# Service Bulletin

## Using 260-0952 Alternator with Pre-2016 Stairmaster Units

*Applies to: 4000-Steppers + SC916 + SC5+ FreeClimber (155015) 7000PT + SM916 + SM5+ Gauntlet (150015)*

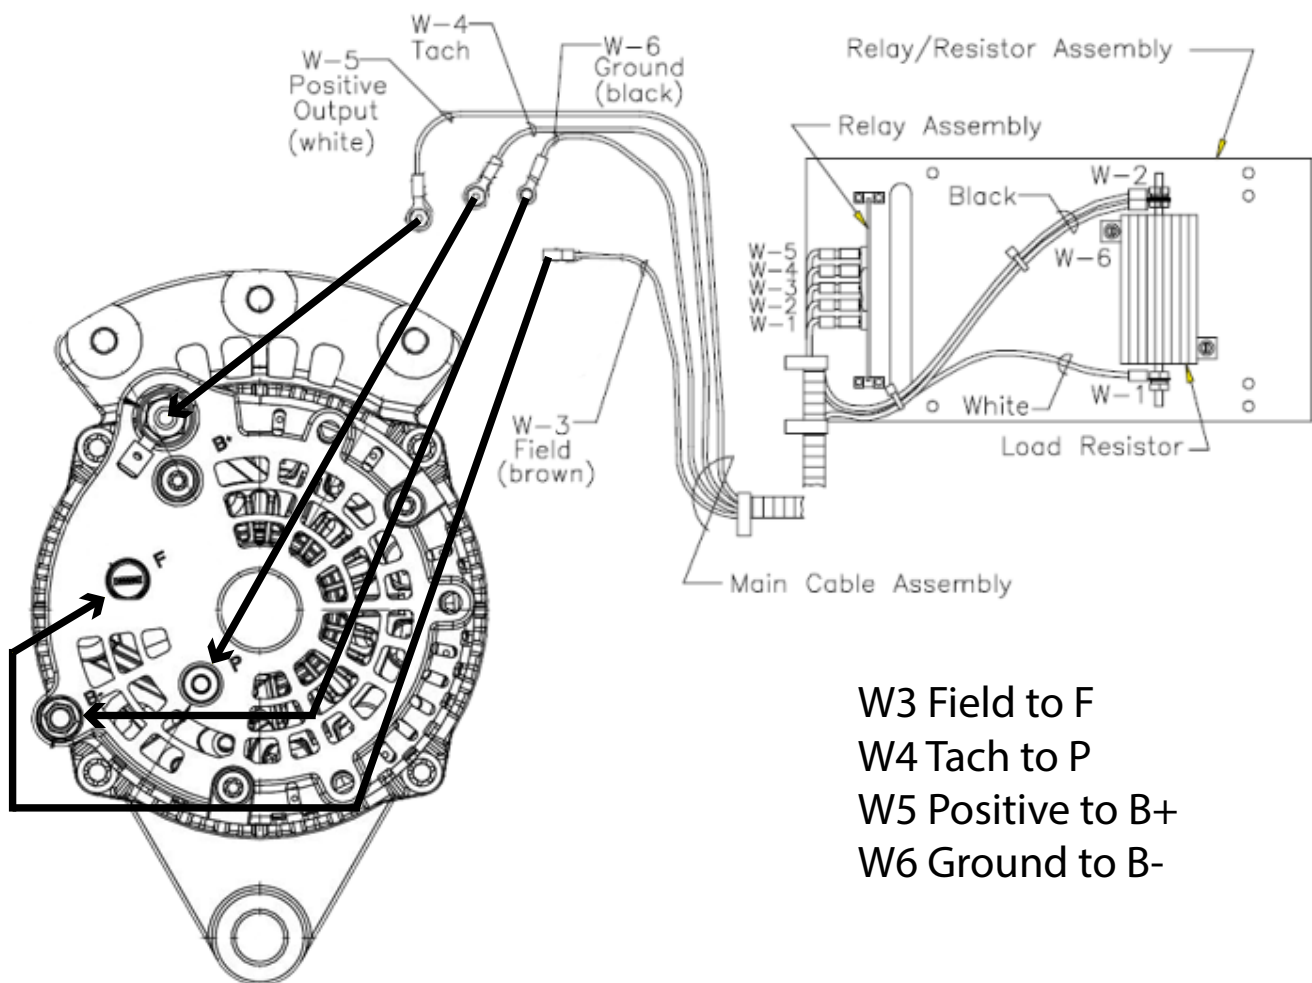
In 2018, a new alternator was introduced (260-0952) to replace the original Stairmaster alternator (SM22900). While this alternator is backwards compatible to pre-2016 units, the wires connect to it slightly different. Please see below:

W3 Field to F  
W4 Tach to P  
W5 Positive to B+  
W6 Ground to B-
